NOTICE OF DECISION — CONSOLIDATED DESIGN REVIEW

New Construction of Restroom/Storage Facility
10 N. Arroyo Boulevard (Desiderio Neighborhood Park)

PLN2018-00034
Council District 6

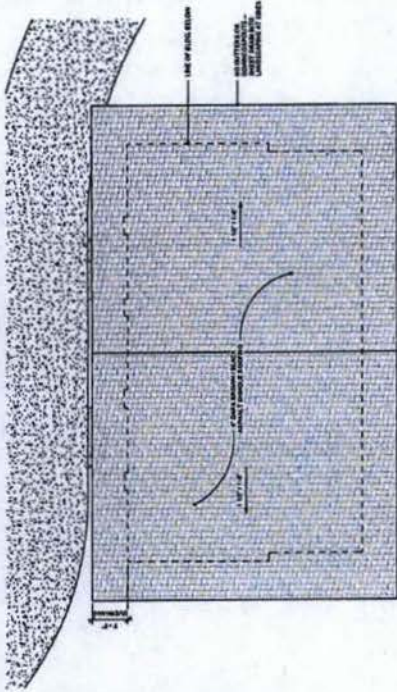
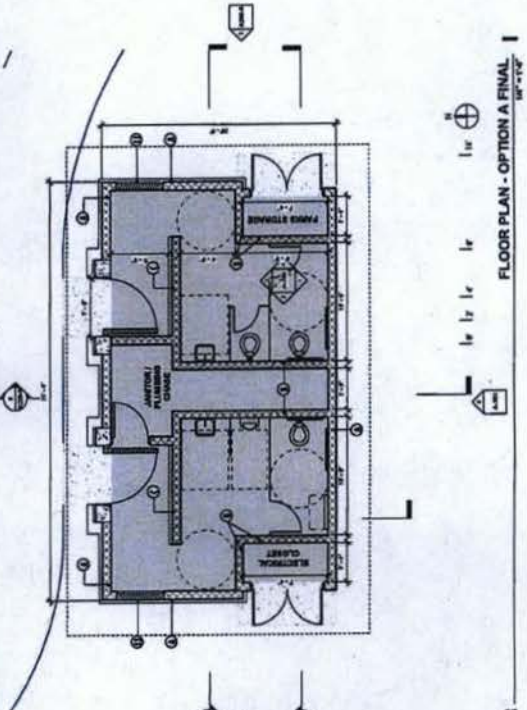
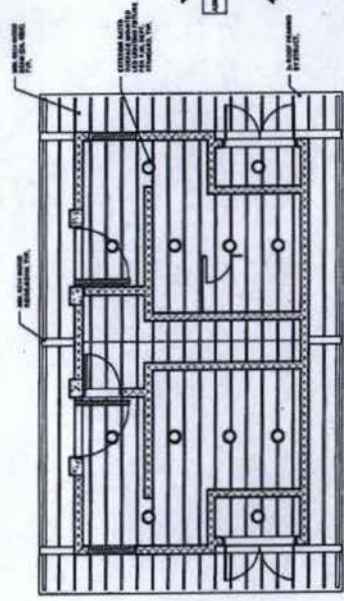
1. Provide manufacturer's product literature and color specifications for the proposed hollow metal doors.
2. Provide details of the corners of the exterior fiber-cement shingle cladding. The proposed fiber-cement lap siding shall be removed and the building shall be clad in shingles only. Consider tapering the shingles where they adjoin the concrete base of the building.

3. Consider removing the step in the building footprint at the rear of the building.
4. Provide a landscape plan for the area immediately surrounding the building.

6. Remove the concrete pilasters and resolve the openings with the exterior cladding material turning the corner into the openings.
7. This project will be subject to a final inspection and sign-off by staff of the Design & Historic Preservation section to ensure that the project is constructed as indicated and specified in the decision letter and that all work is performed consistent with the approved plans.
